Work Order ID 125071

Item Name: Lightweight Interior Ceiling Panel

A	NEW ISSUE	RF	14.03.24
REV.	DESCRIPTION	BY	DATE
DESIGN	RF	DART AEROSPACE LTD	
DRAWN	RF	HAWKESBURY, ONTARIO, CANADA	
CHECKED		DRAWING NO.	REV. A
MFG. APPR.	N/A	DSI 9686	SHEET 1 OF 1
APPROVED		TITLE	SCALE
DE APPR.		ALTERNATE INSTALLATION	NTS
DATE	14.03.24	COPYRIGHT © 2014 BY DART AEROSPACE LTD THIS DOCUMENT IS PRIVATE AND CONFIDENTIAL AND IS SUPPLIED ON THE EXPRESS CONDITION THAT IT IS NOT TO BE USED FOR ANY PURPOSE OR COPIED OR COMMUNICATED TO ANY OTHER PERSON WITHOUT WRITTEN PERMISSION FROM DART AEROSPACE LTD.

A	NEW ISSUE	RF	14.03.24
REV.	DESCRIPTION	BY	DATE
DESIGN	RF	DART AEROSPACE LTD HAWKESBURY, ONTARIO, CANADA	
DRAWN	RF		
CHECKED		DRAWING NO.	REV. A
MFG. APPR.	N/A	DSI 9691	SHEET 1 OF 2
APPROVED		TITLE	SCALE
DE APPR.		BRACKET INSTALLATION	NTS
DATE	14.03.24	COPYRIGHT © 2014 BY DART AEROSPACE LTD THIS DOCUMENT IS PRIVATE AND CONFIDENTIAL AND IS SUPPLIED ON THE EXPRESS CONDITION THAT IT IS NOT TO BE USED FOR ANY PURPOSE OR COPIED OR COMMUNICATED TO ANY OTHER PERSON WITHOUT WRITTEN PERMISSION FROM DART AEROSPACE LTD.

Figure 1. - LH Side Overhead Panel

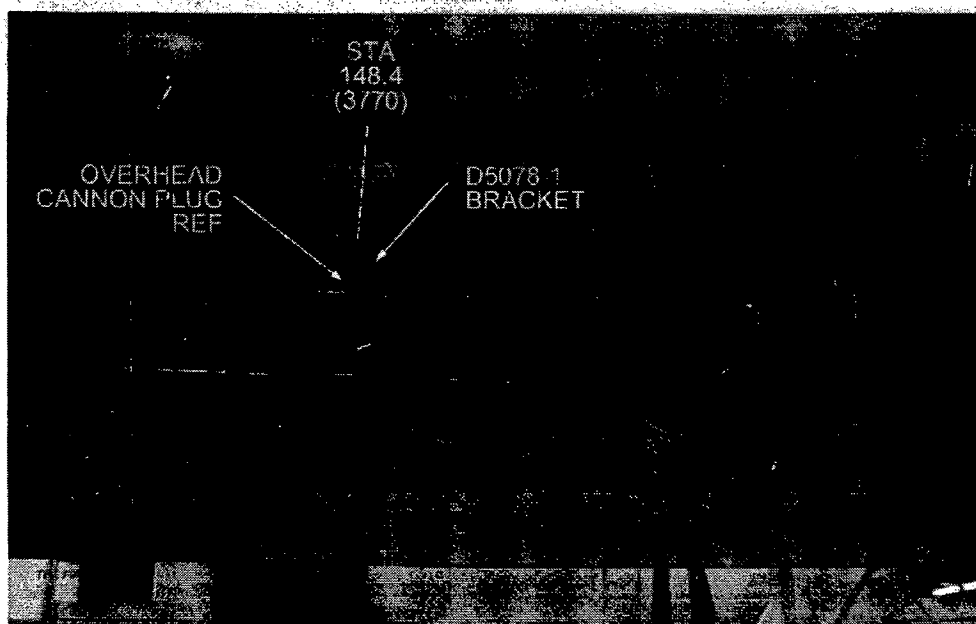
This procedure is added after step 3.1.39 of IIN-D139-816 Rev. D.

- 2.1 Position the D5078-1 Bracket on the LH side of the cabin overhead by temporarily removing 2x MS27039-1 screws as shown in Figure 1. Transfer 2x $\varnothing 0.204$ " (#6 drill) holes from airframe to the D5078-1 Bracket. Deburr and touch-up holes with MIL-P-85582 or MIL-P-23377 primer.
- 2.2 Install D5078-1 Bracket using existing 2x MS27039-1 screws and washers as shown in Figure 1.
- 2.3 Install overhead cannon plug in the D5078-1 Bracket using existing NAS1801/1802 screws and existing AS85049/95-20A-A Perimeter Mounting Flange as shown in Figure 2.
- 2.4 Reconnect wire harness to overhead cannon plug as shown in Figure 2.

Figure 2. - D5078-1 Bracket Installation

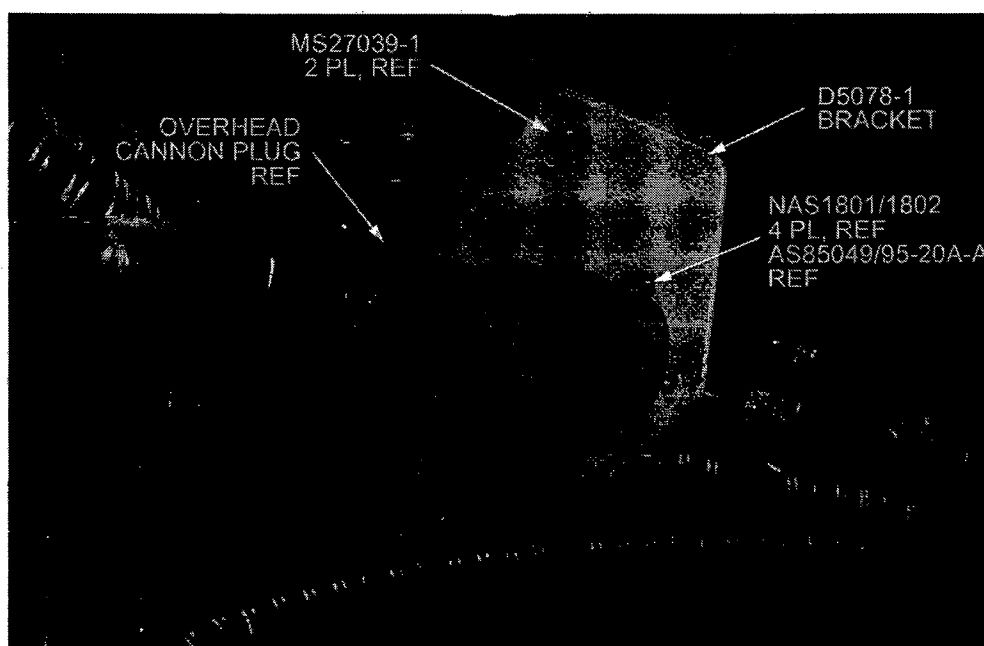
The D5078-1 bracket has been added to D139-816-011 Kits at CHG 005 and later. Customers who wish to obtain the D5078-1 Bracket for a kit that has already been installed can procure the DSI 9691-011 kit from Dart as outlined below.
